SUNDRY NOTICES AND REPORTS ON WELLS
Do not use this form for proposals to drill or to re-enter an abandoned well. Use form 3160-3 (APD) for such proposals.

NEW WELLHEAD

MEAN GREEN 23 FED COM 1H & MEAN GREEN 26 FED COM 1H

CONDITIONS OF APPROVAL

SURFACE WELLHEAD LAYOUT
UNIHEAD, UH-1,SOW,
DEVON ENERGY, ODESSA

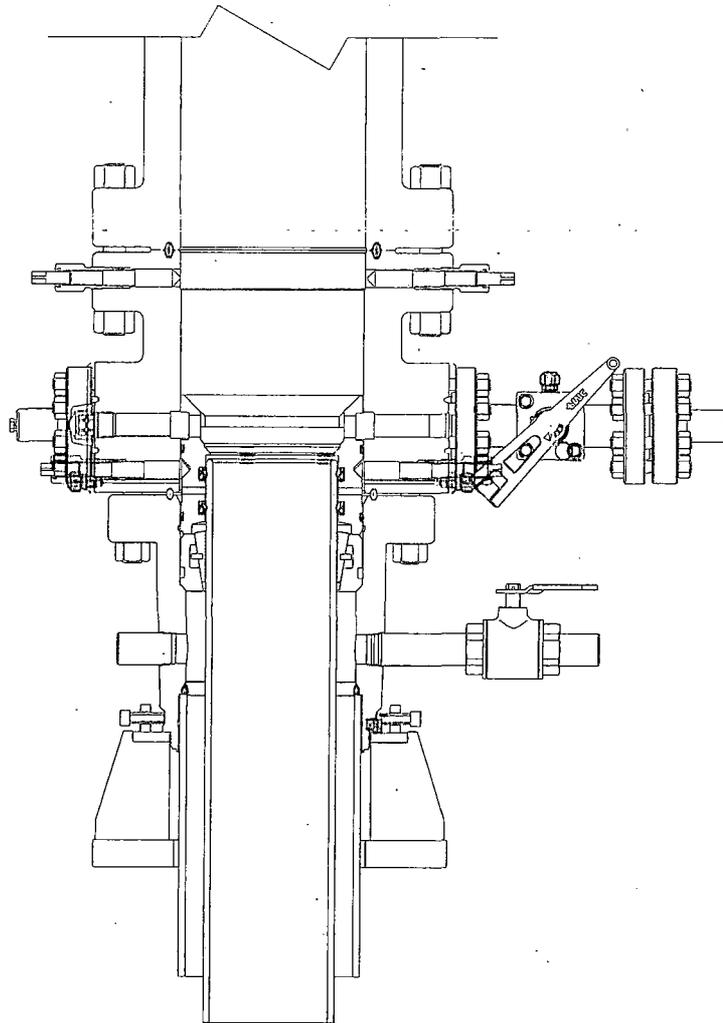
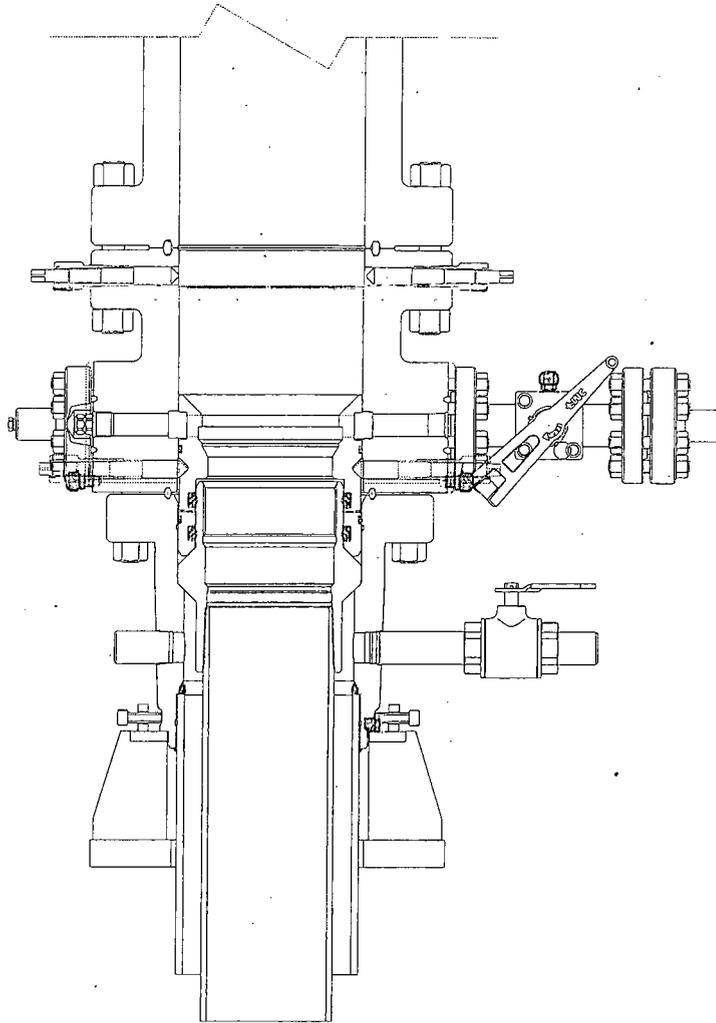
Devon Energy Production Co., L.P. respectfully proposes using a multi-bowl wellhead assembly (FMC Uni-head). This assembly will only be tested when installed on the surface casing. Minimum working pressure of the blowout preventer (BOP) and related equipment (BOPE) required for drilling below the surface casing shoe shall be 3000 (3M) psi.

- Wellhead will be installed by FMC's representatives.
- If the welding is performed by a third party, the FMC's representative will monitor the temperature to verify that it does not exceed the maximum temperature of the seal.

- FMC representative will install the test plug for the initial BOP test.
- FMC will install a solid steel body pack-off to completely isolate the lower head after cementing intermediate casing. After installation of the pack-off, the pack-off and the lower flange will be tested to 3M, as shown on the attached schematic. Everything above the pack-off will not have been altered whatsoever from the initial nipple up. Therefore the BOP components will not be retested at that time.

- if the cement does not circulate and one inch operations would have been possible with a standard wellhead, the well head will be cut and top out operations will be conducted.

- Devon will pressure test all seals above and below the mandrel (but still above the casing) to full working pressure rating.
- Devon will test the casing to 70% of burst or 1500 psi, whichever is greater, as per Onshore Order #2.

After running the 13-3/8" surface casing, a 13-5/8" BOP/BOPE system with a minimum rating of 3M will be installed on the FMC Uni-head wellhead system and will undergo a 250 psi low pressure test followed by a 3,000 psi high pressure test. The 3,000 psi high and 250 psi low test will cover testing requirements a maximum of 30 days, as per Onshore Order #2. If the well is not complete within 30 days of this BOP test, another full BOP test will be conducted, as per Onshore Order #2.

After running the 9-5/8" intermediate casing with a mandrel hanger, the 13-5/8" BOP/BOPE system with a minimum rating of 3M will already be installed on the FMC Uni-head. Please find attached the wellhead schematic.

Original COA still stand with the following drilling modifications:

- 1. Operator has proposed a multi-bowl wellhead assembly. This assembly will only be tested when installed on the surface casing. Minimum working pressure of the blowout preventer (BOP) and related equipment (BOPE) required for drilling below the surface casing shoe shall be 3000 (3M) psi.**

- a. Wellhead shall be installed by manufacturer's representatives, submit documentation with subsequent sundry.**
 - b. If the welding is performed by a third party, the manufacturer's representative shall monitor the temperature to verify that it does not exceed the maximum temperature of the seal.**

- c. Manufacturer representative shall install the test plug for the initial BOP test.**
 - d. Operator shall perform the intermediate casing integrity test to 70% of the casing burst. This will test the multi-bowl seals.**

- e. If the cement does not circulate and one inch operations would have been possible with a standard wellhead, the well head shall be cut off, cementing operations performed and another wellhead installed.**
